Thursday, October 22, 2026 7:00 PM
Educational Services Center (ESC), 401 E. Hancock Street, Lansdale, PA 19446

RE: North Penn High School BP-2
Change Order Request #23 ASI 01 – Additional Shaft wall

PROJECT: *(name and address)* North Penn High School Renovations Bid Package 2	**CONTRACT INFORMATION:** Contract For: Mechanical Construction Date: 08-14-2026	**ASI INFORMATION:** ASI Number: 01 Date: 01-20-2026
OWNER: *(name and address)* North Penn School District 401 E. Hancock Street Landsdale, PA 19446	**ARCHITECT:** *(name and address)* Hord Coplan Macht, Inc. d/b/a SCHRADERGROUP Studio 555 E. North Lane, Suite 5100 Conshohocken , PA 19428	**CONTRACTOR:** *(name and address)* JBM Mechanical, Inc 3273 Gun Club Road Nazareth, PA 18064

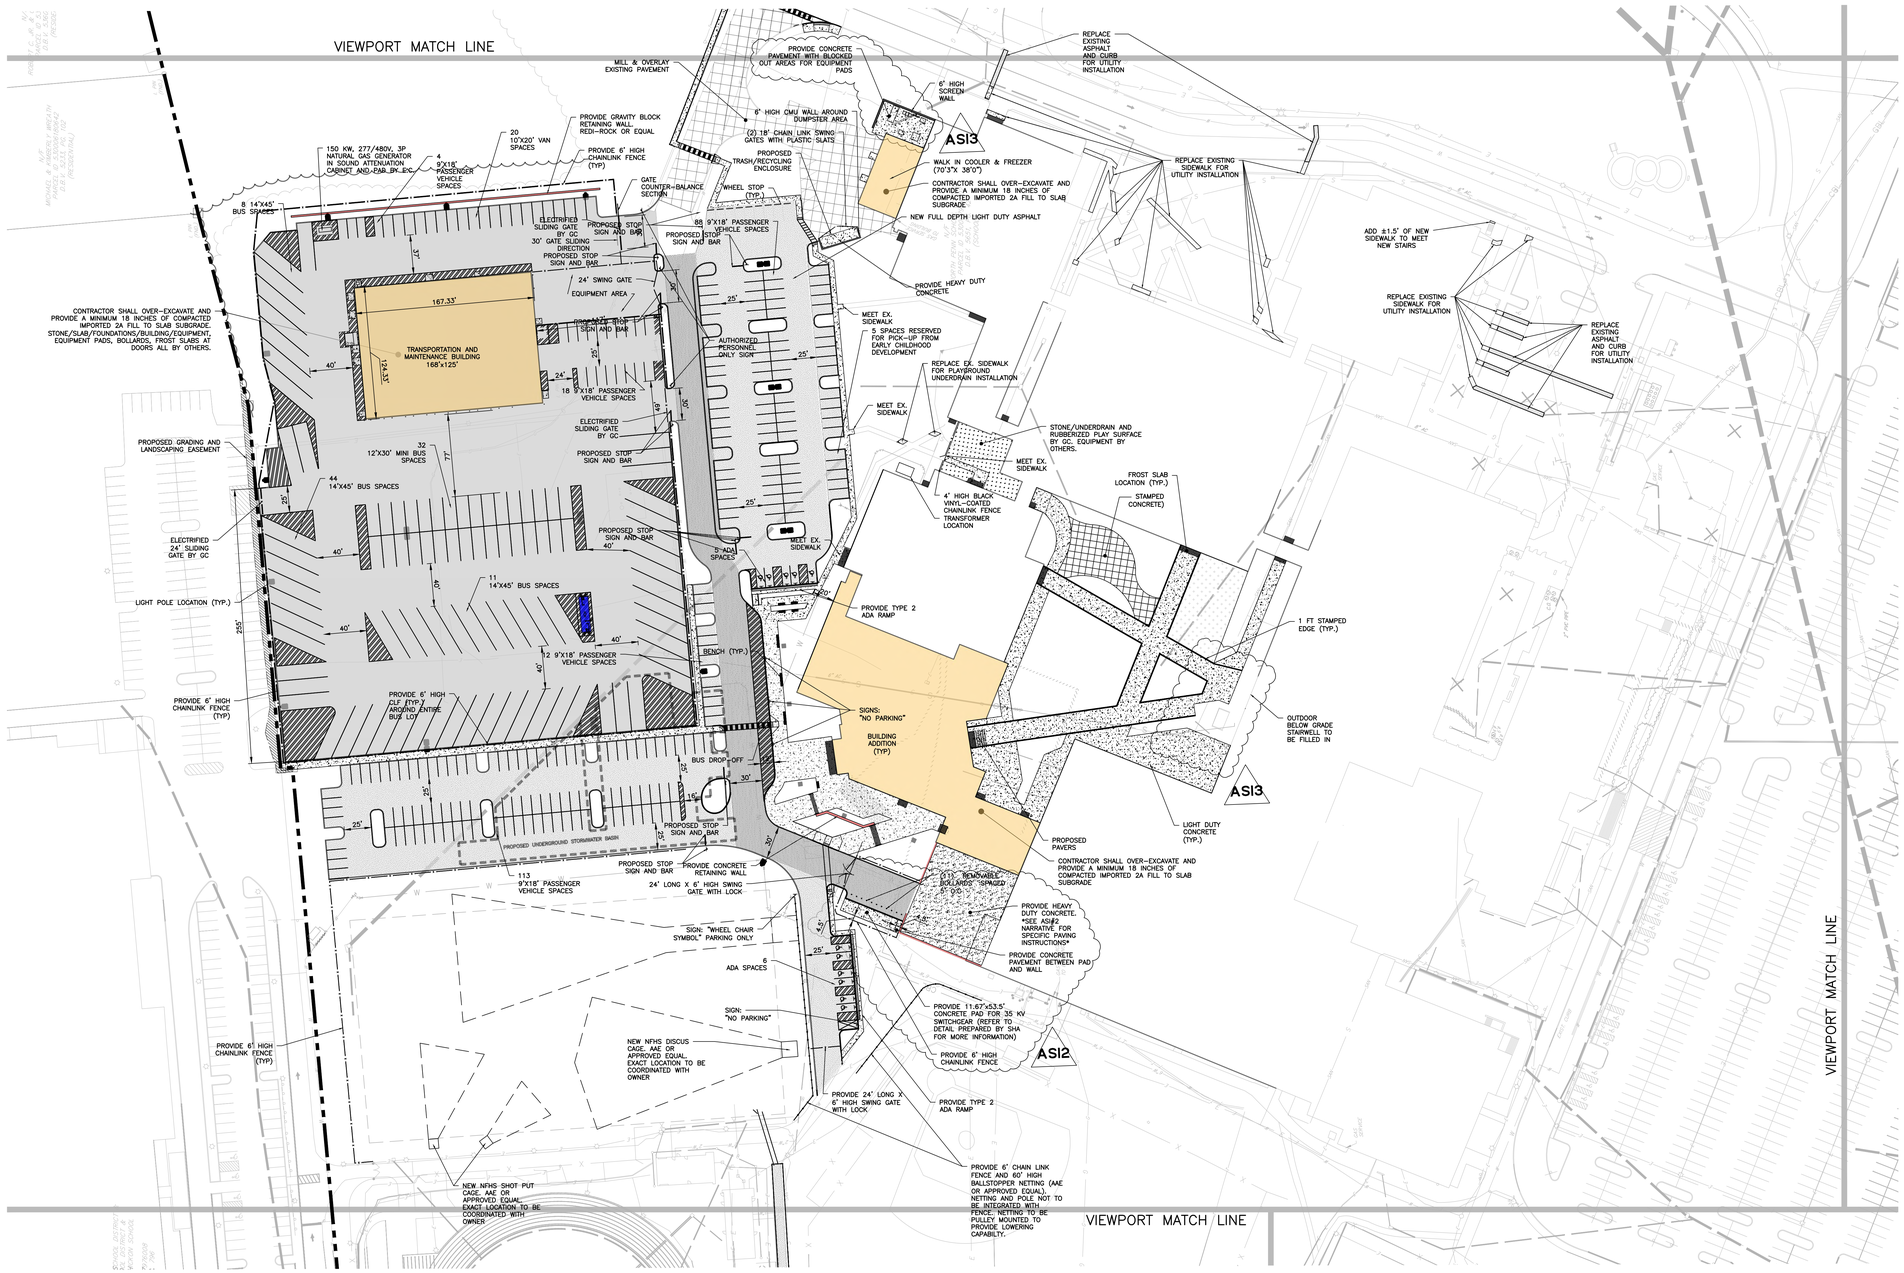
- **To raise the existing inlet in Area B Equipment Yard to allow proper drainage**

4. Utility Plan A (BP2-C022) has been modified to make plan revisions including but not limited to:
   - **To show the added structure B62B connection to the roofdrains leading to B62.**
     *** Please note that while this drawing shows the revised ductbank routing to Sumneytown Pike from ASI#2, revised E&S drawings BP2-C027 and BP2-C028 will first be submitted to the conversation district for review and approval of this as a field change. The review process is expected to parallel WEC's duct bank test pit digs. Work on the electrical duct bank should not commence until both the routing is considered viable with minimal rock removal expected and approval is received from the conservation district.**

BP2-CSKE-10 SCALE: 1/8" = 1'-0"

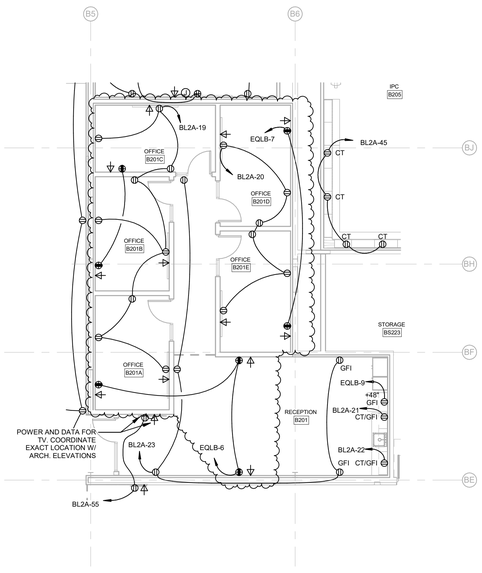
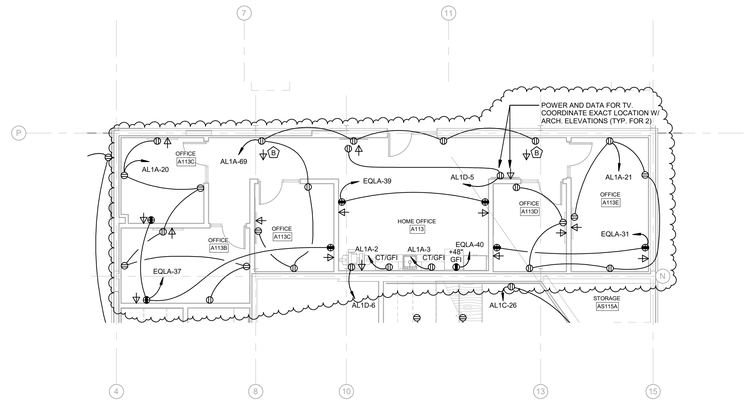
14.03 Sketch BP2-CSKE-10; **ADD** sketch BP2-CSKE-10 dated 06/18/2026.
